SUBMITTAL OF DANGEROUS WASTE PERMIT PACKAGE PTF-009, REVISION 2, FOR THE PRETREATMENT FACILITY

Permit Package PTF-009, Revision 2, Supplemental
Permit Package for FRP-VSL-00002A, FRP-VSL-00002B,
FRP-VSL-00002C, and FRP-VSL-00002D Vessel Alterations

Supplemental Permit Package PTF-009, Rev. 2 Description
Vessel Alterations to FRP-VSL-00002A/B/C/D

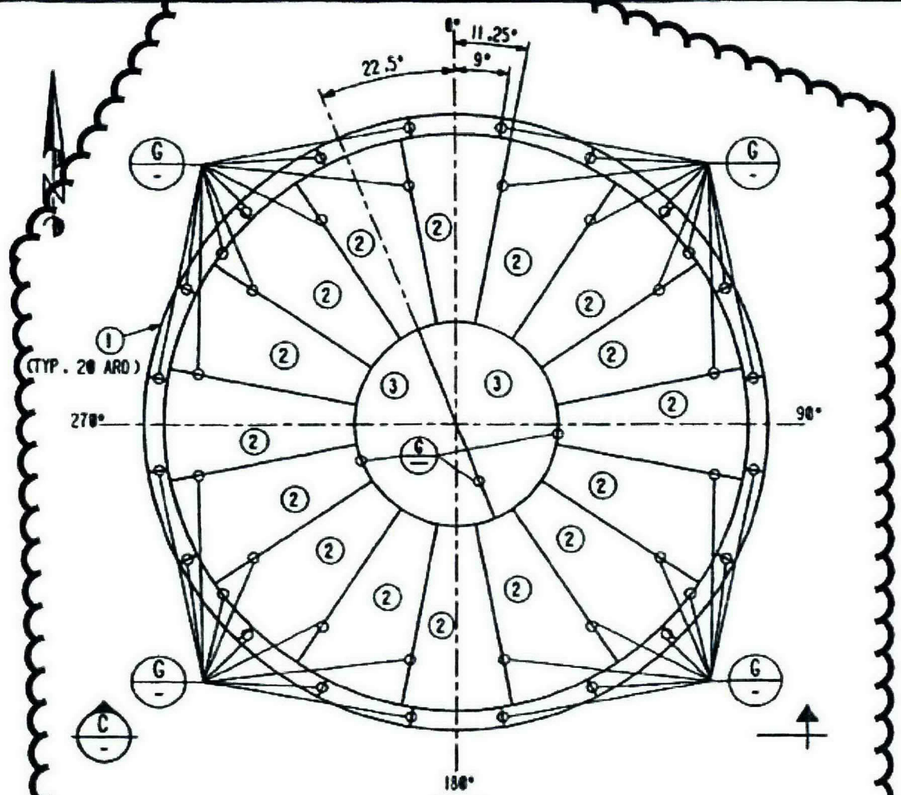
ADD KNUCKLE STIFFENERS BY RPP-WTP ON HOLD

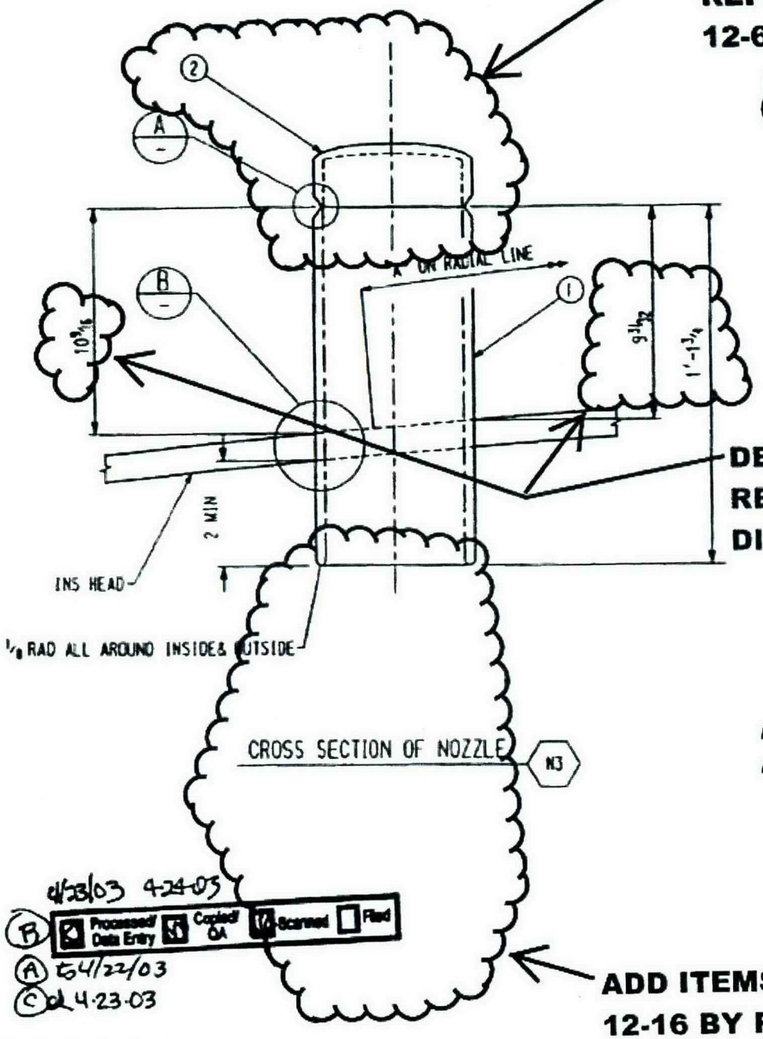
DELETE ITEM 12-2
REPLACE WITH ITEM
12-6 BY RPP-WTP

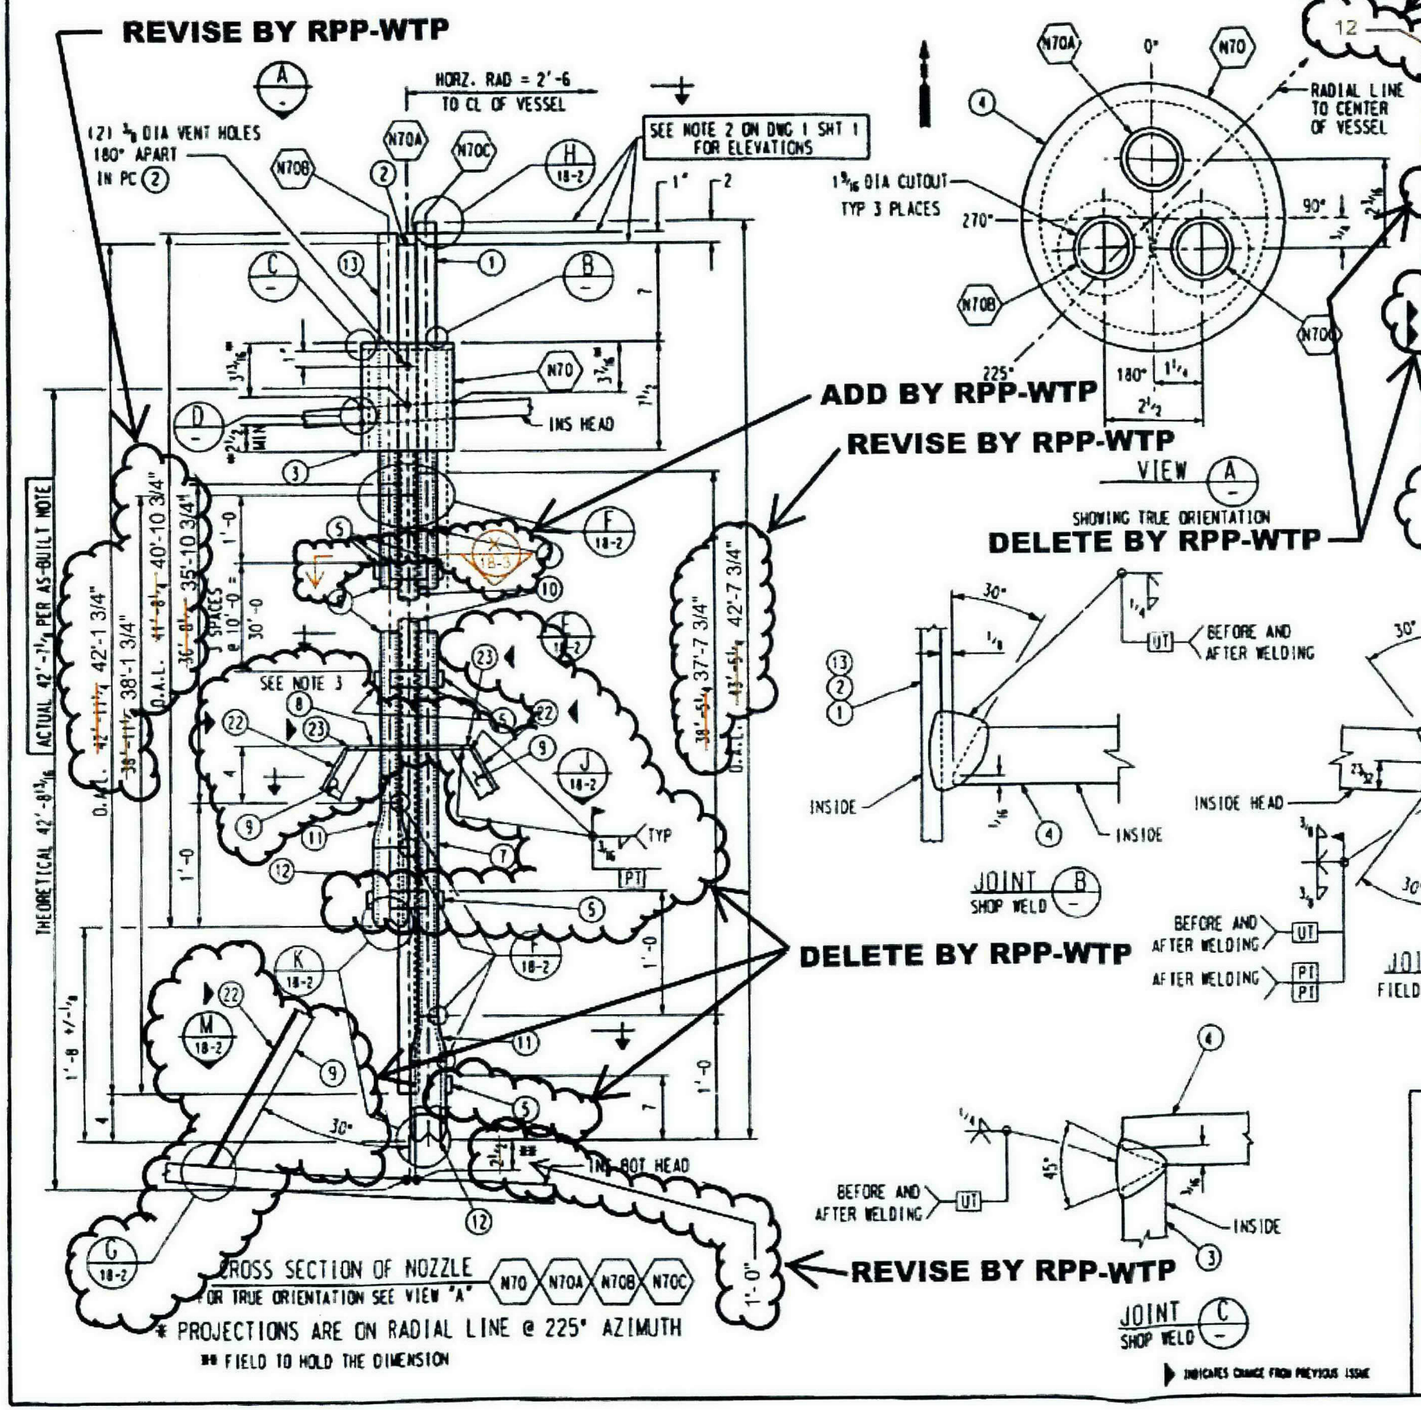
REVISE BY RPP-WTP

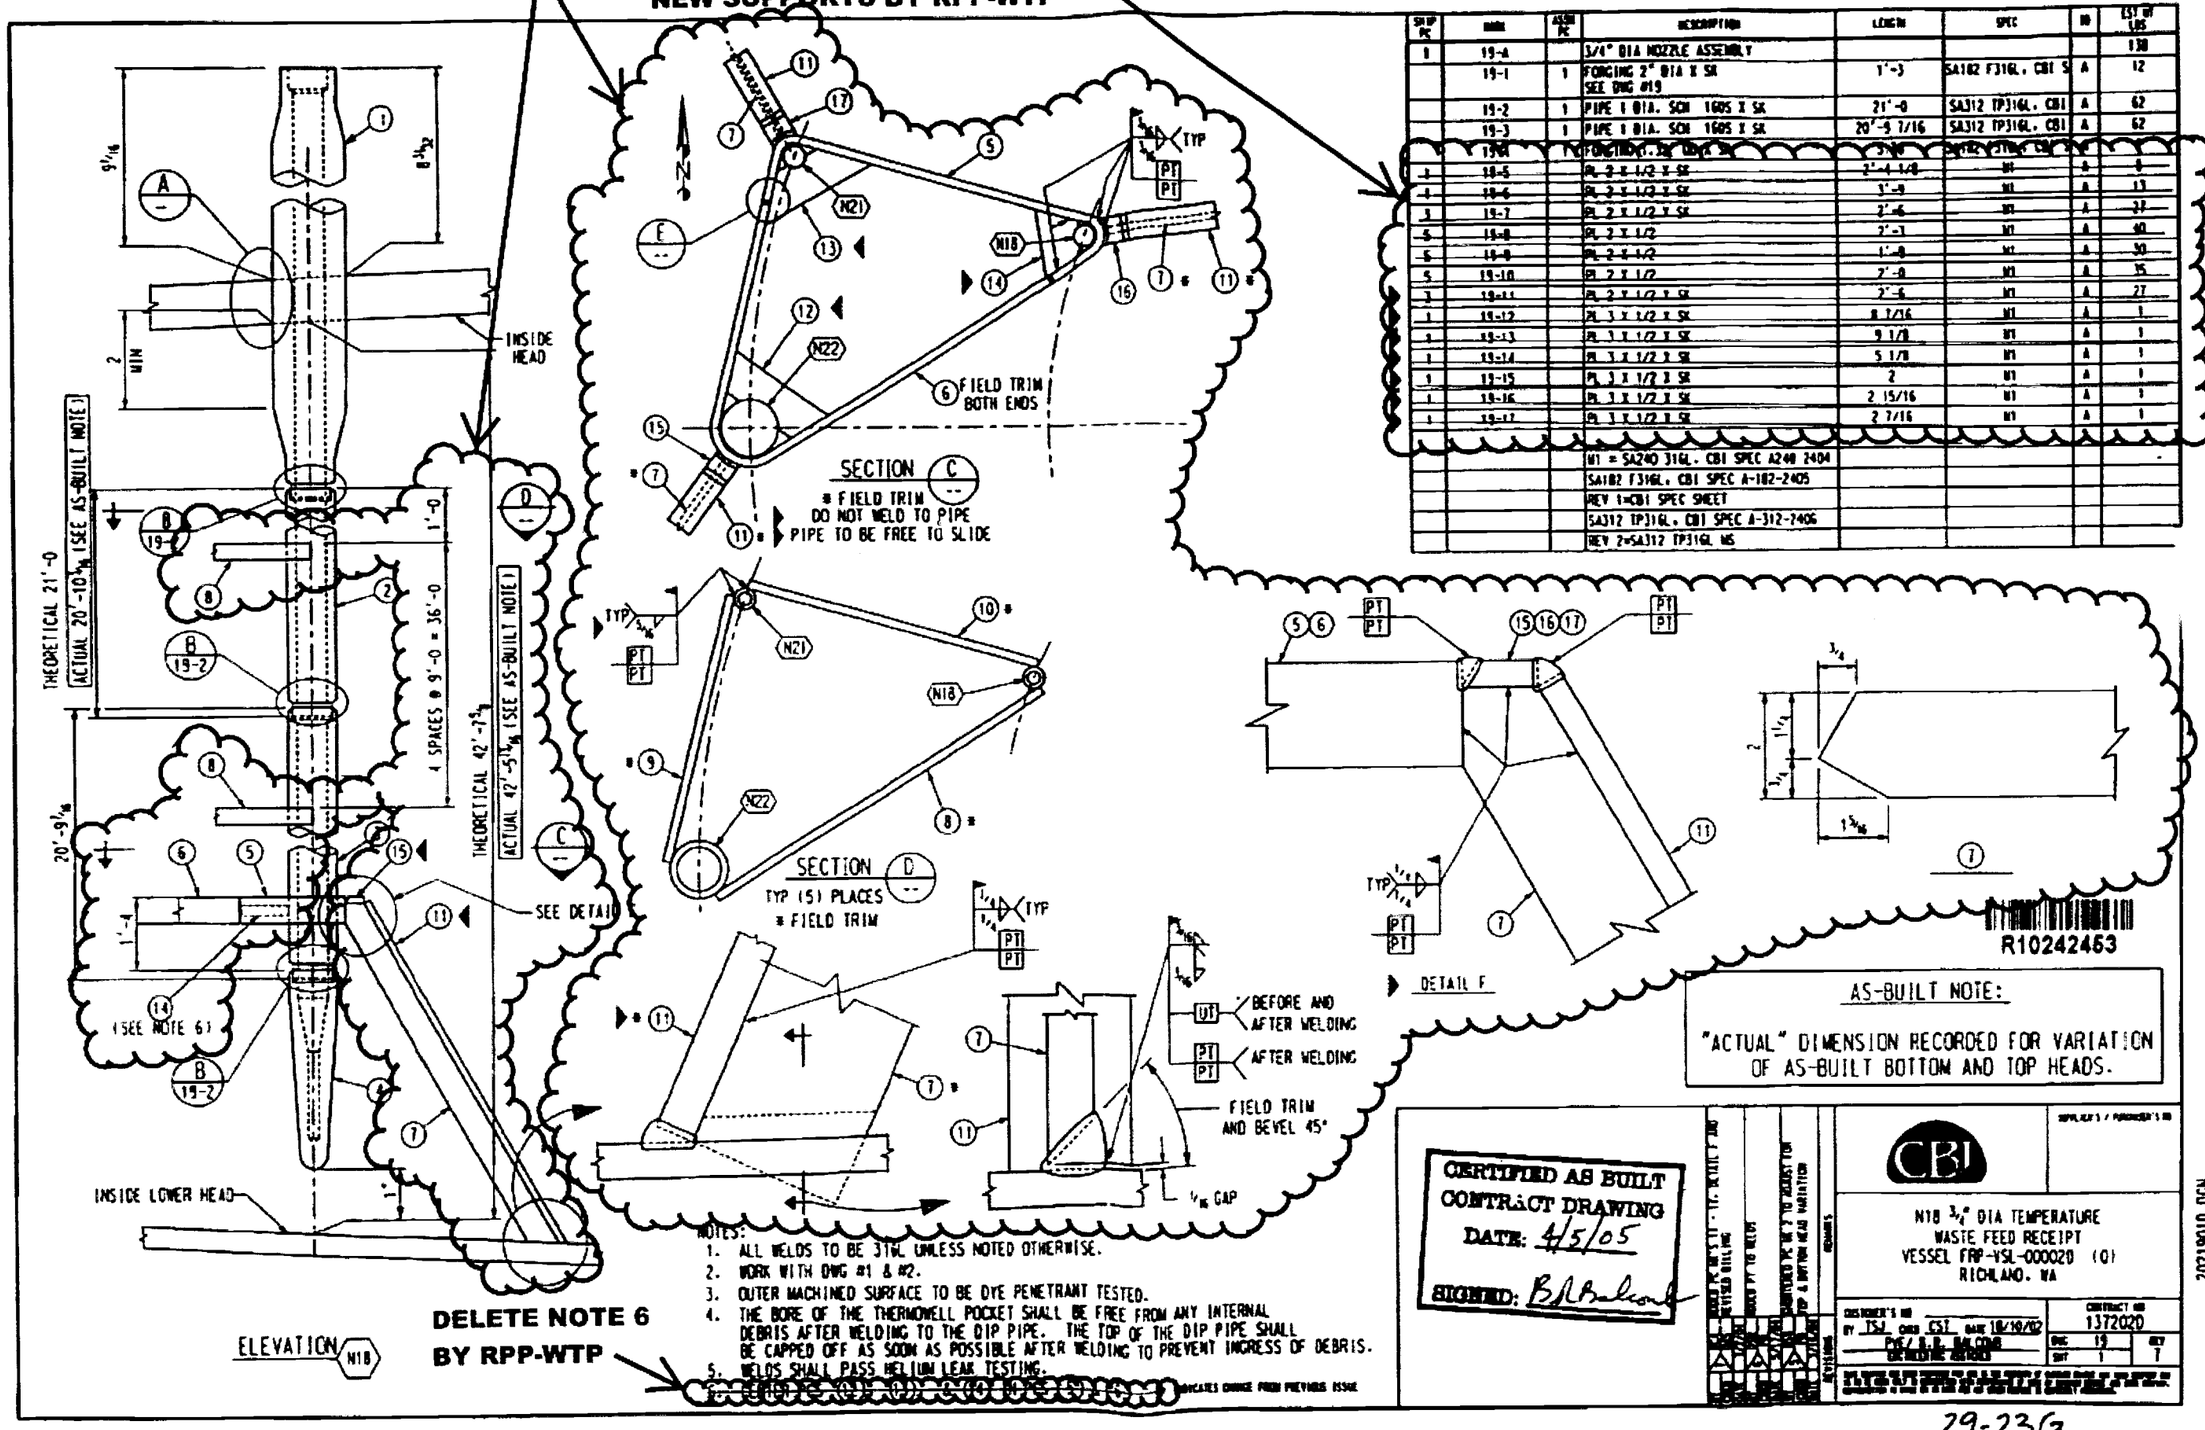
DELETE AND REPLACE WITH NEW SUPPORTS BY RPP-WTP

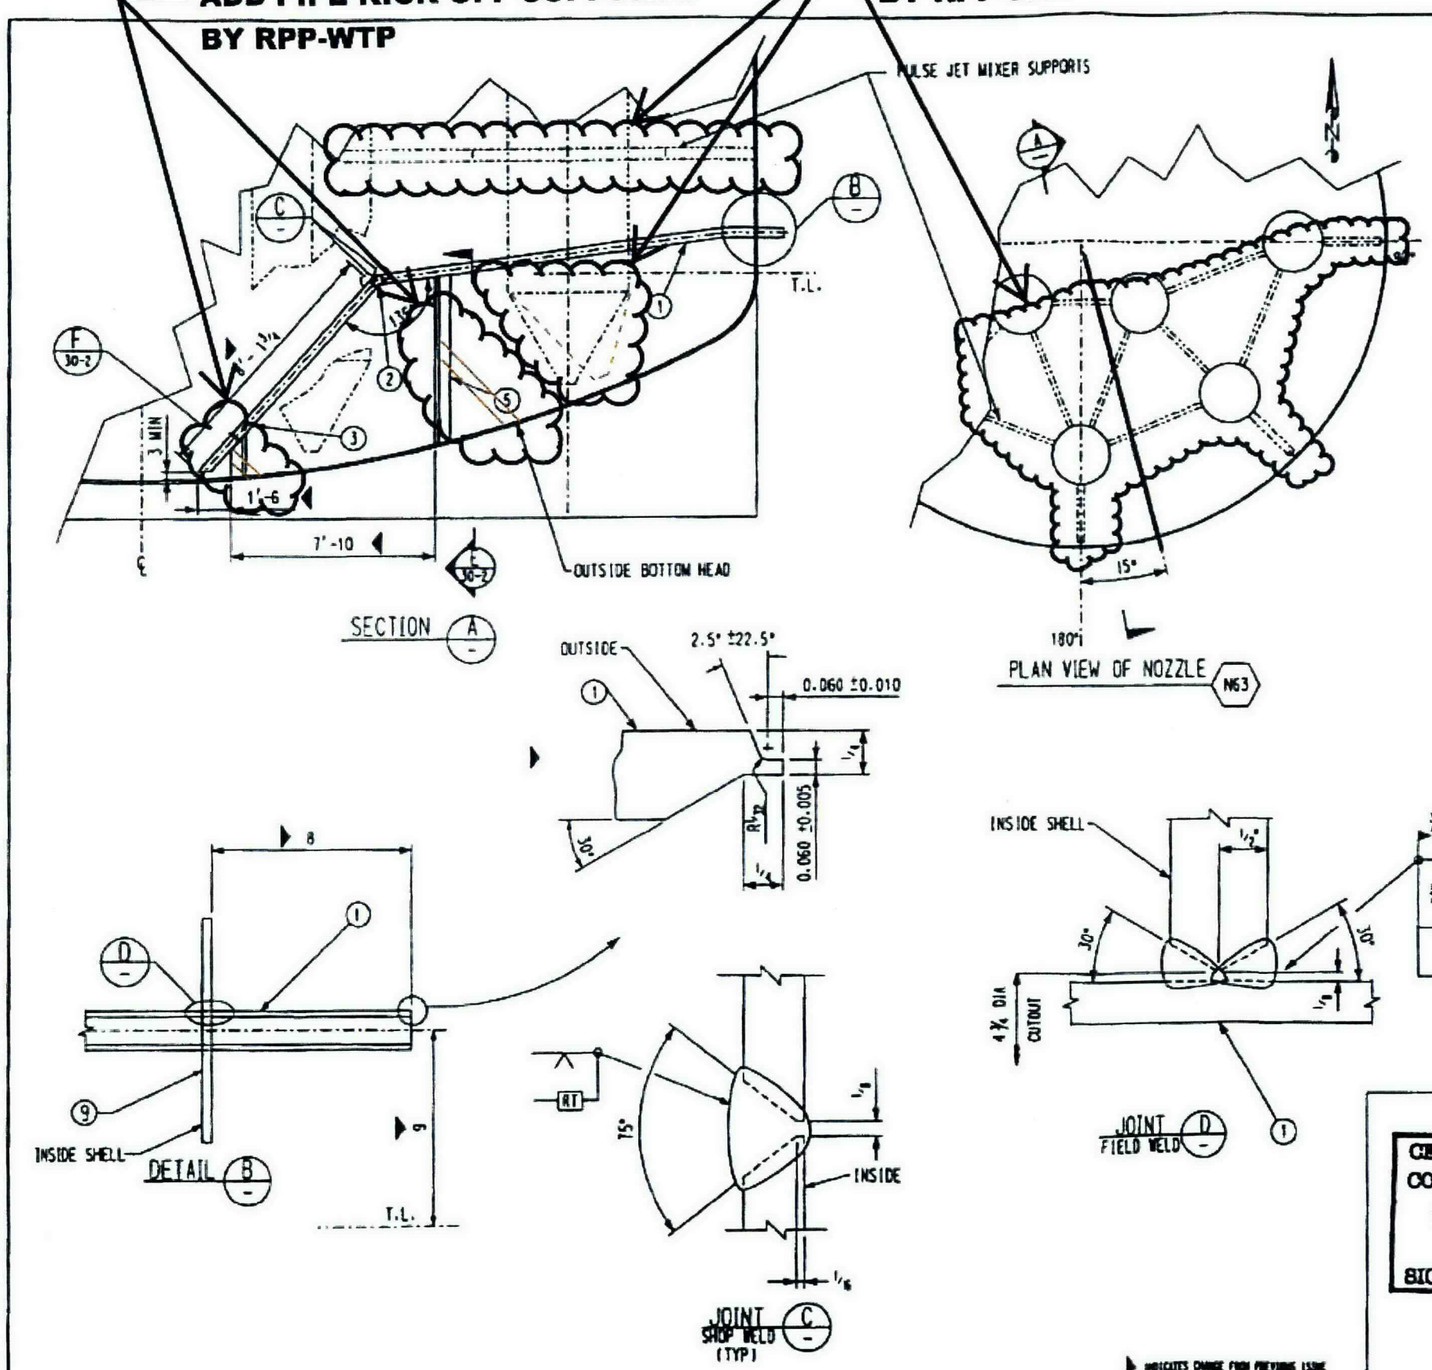
UPDATE DEPICTION BY RPP-WTP

WASH RING PLAN VIEW
N56-N62

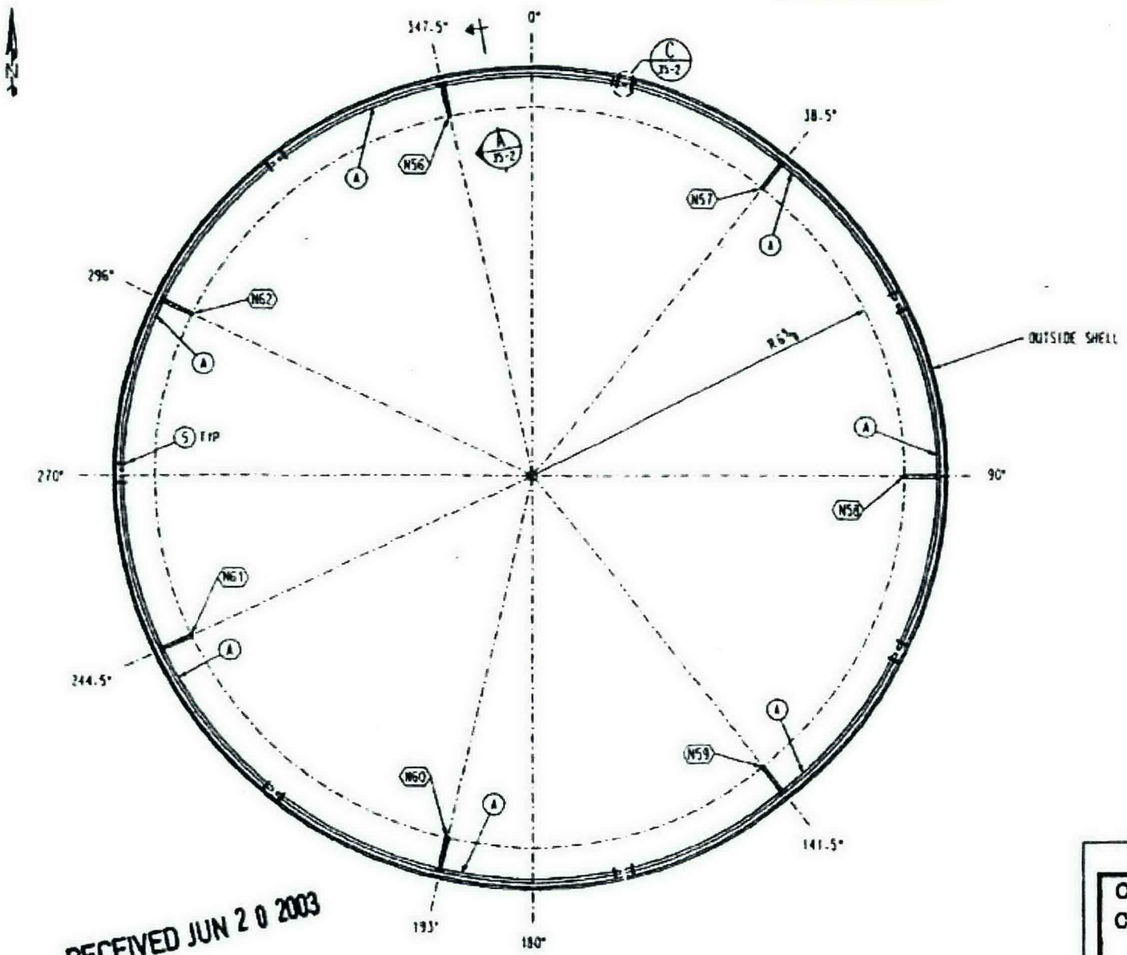
REVISE BY RPP-WTP ON HOLD → 160S
